revised block plan for 95 North Farm Road Lancing AWDM/2027/20

95 North Farm Road. Lancing

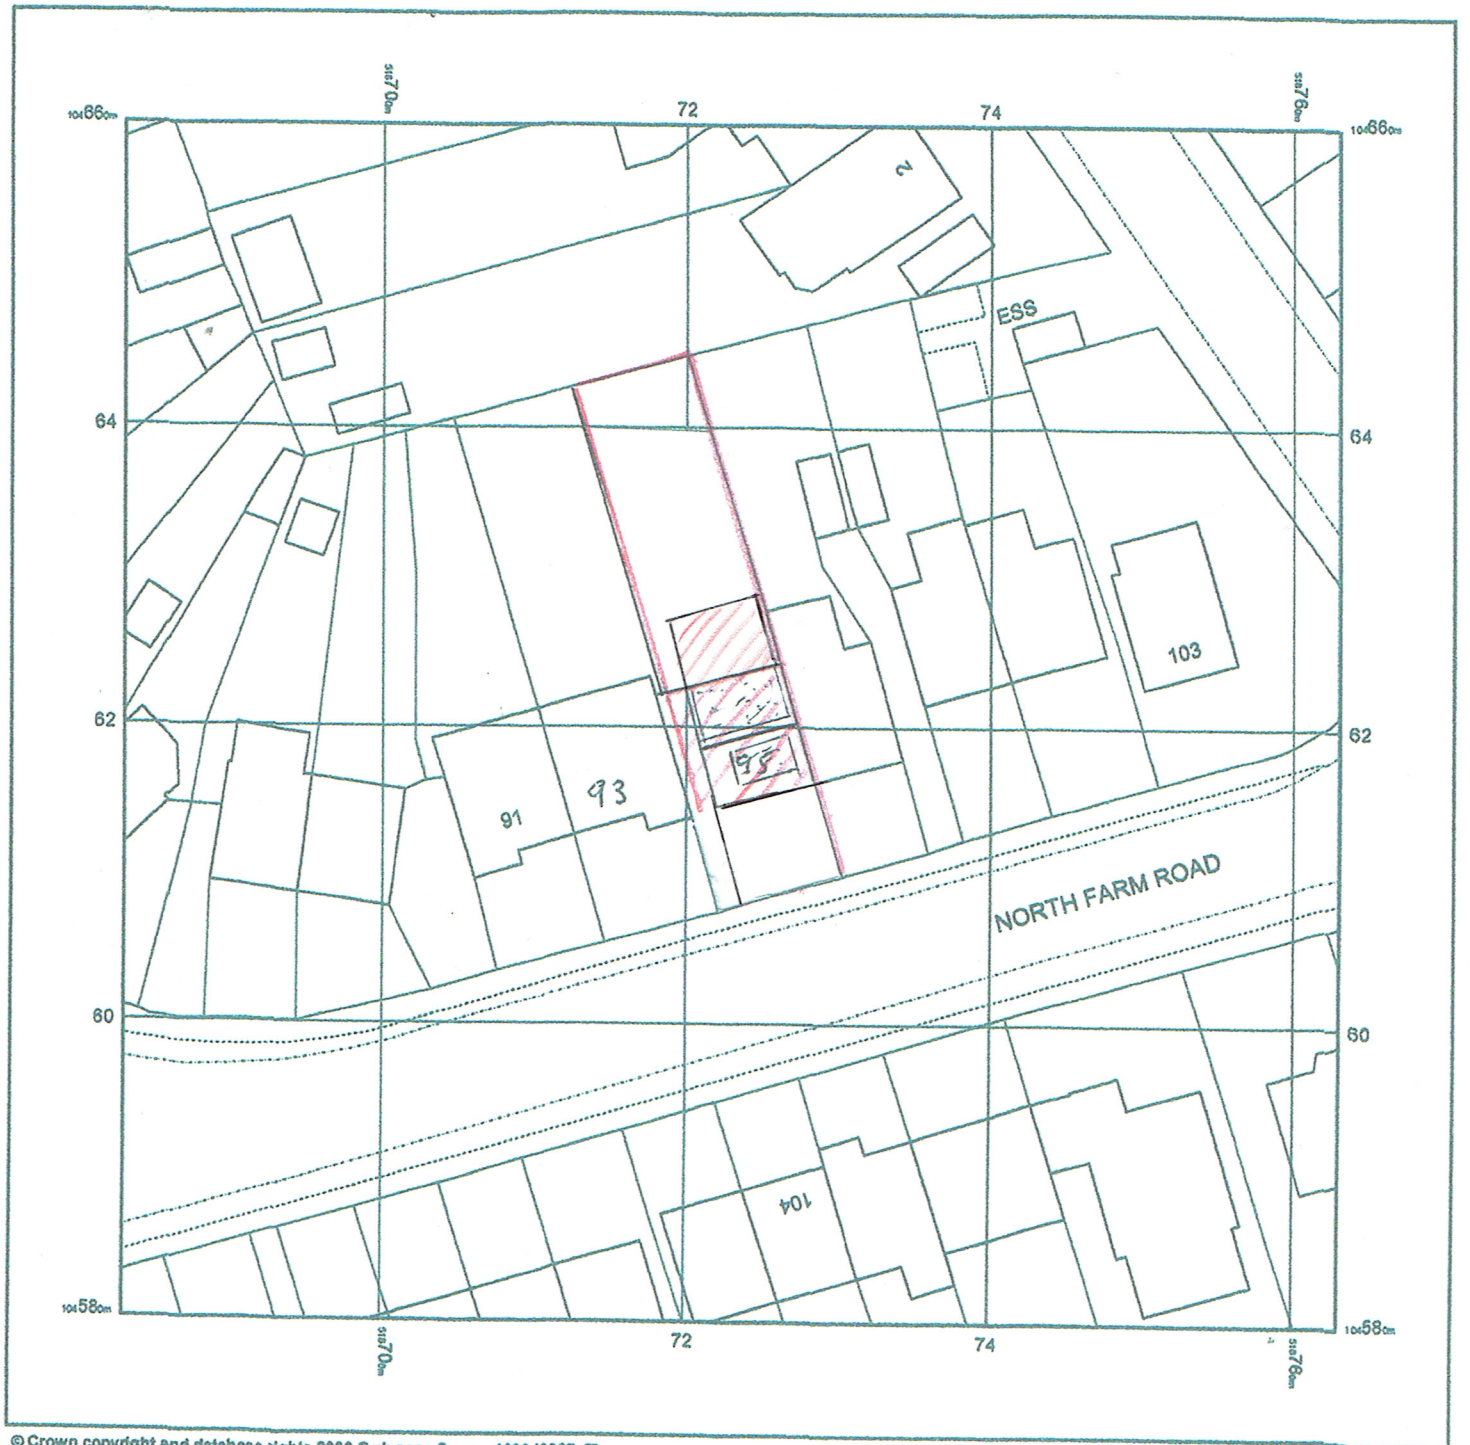
Please could you confirm that the fence has been removed from the application and submit a revised block plan.

Sorry. Clanger. Shouldn't rush things, attached Revised 1-500.
